SERVICE & PARTS TECHNICAL INFORMATION

79-A-1

CYLINDER HEAD TORQUE SPECIFICATION

TR7

FIGURE I

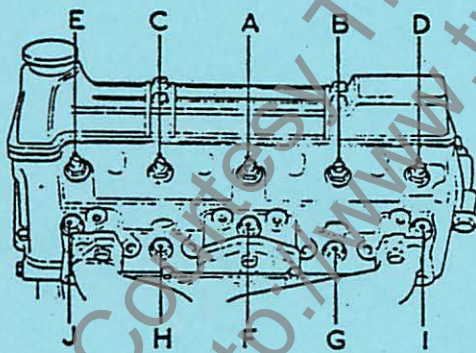
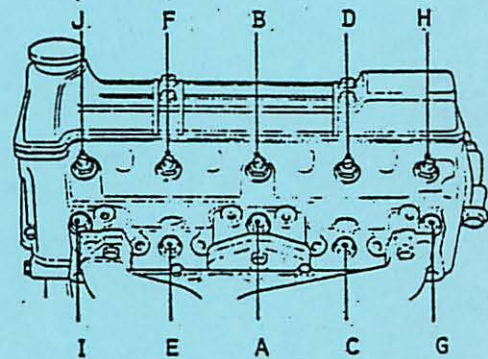
The 1978/79 scheduled maintenance and specification cards quote the cylinder head torque for the TR7 at 45-55 lbs ft. This torque specification only applies to vehicles prior to engine no. CV10330. Vehicles subsequent to engine CV10330 incorporate new cylinder head bolts, studs, nuts and washers requiring a new tightening sequence and a revised torque figure of 45-50 lbs ft.

TORQUE 45-55 lbs/ft.

Previous Head Tightening Sequence

TORQUE 45-50 lbs/ft.

New Head Tightening Sequence
